Joint Regional Planning Panel

JRPP Number:	2013SYE115
DA Number:	12(206)
Local Government Area:	City of Botany Bay
Proposed Development:	<p>The development proposes the construction of 164 residential units within Buildings D, E and F comprising the following;</p> <ul style="list-style-type: none">• To construct Building D being a 6 storey building containing 41 units;• To construct Building E being a 7 storey building containing 63 units;• To construct Building F being a 6 storey building containing 60; and,• To construct 346 underground car parking spaces. (285 spaces are to be dedicated to Buildings D, E and F).
Street Address:	42-44 Pemberton Street, Botany
Applicant:	Krikis Tayler Architects
Number of Submissions:	1 – petition signed by 44 neighbouring/surrounding residents.
Recommendation:	Refusal
Report by:	Rodger Dowsett, Director Planning and Development, City of Botany Bay

Précis

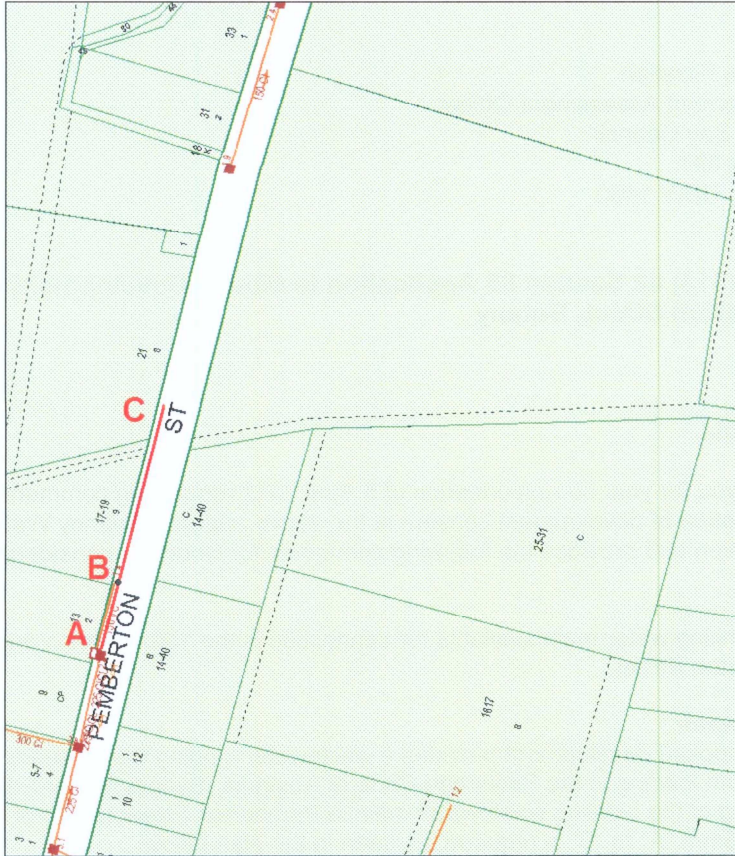
The proposed development provides a wastewater loading that exceeds the recommended maximum loading in the Sewerage Code of Australia (Sydney Water Edition WSA 02-2002).

- *Upsize the wastewater main from 150mm to 225mm from 'A' to 'B', see Figure 1*
- *Extend the upsized 225mm wastewater main from 'B' to 'C', see Figure 1.*
- *Provide a point of connection of the new main, at least one metre past the property's boundary.*

Overshadowing plans at 2pm during Winter solstice

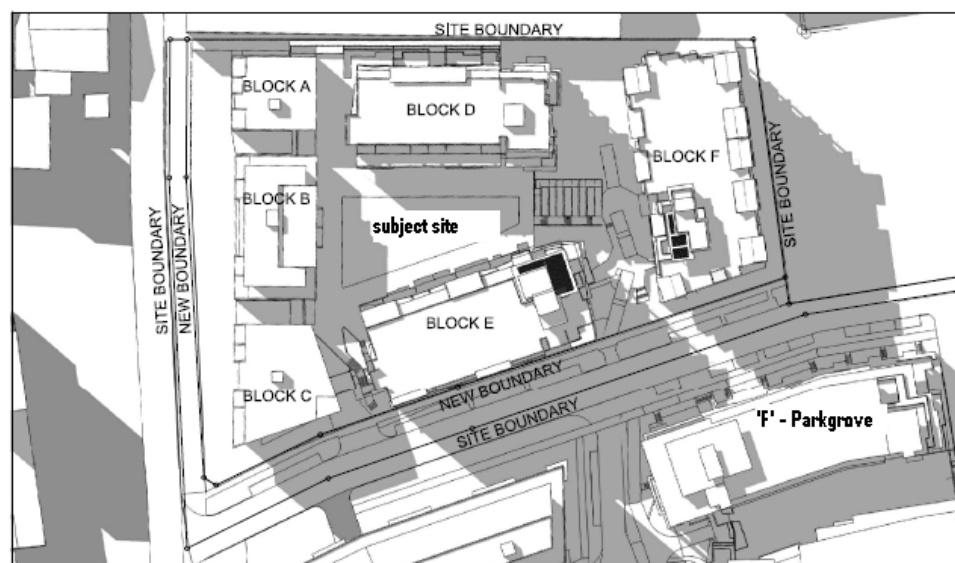
- *The distance between existing buildings G & H (townhouses) and buildings E & F is too minimal to further increase the height of buildings E & F. This would impose a greater shadow over G & H at all times of the year, as well as decrease the privacy of G & H townhouse residents and residents on the eastern side of Wilson Street.*

Officer's Comments: Below is a shadow diagram of the proposal, which clearly indicates that the buildings the subject of this report will not adversely affect the amenity of the recently completed townhouses on Wilson Street. It seems apparent that the objector/s are referring to Buildings E and F on the Parkgrove One site and not the subject site.
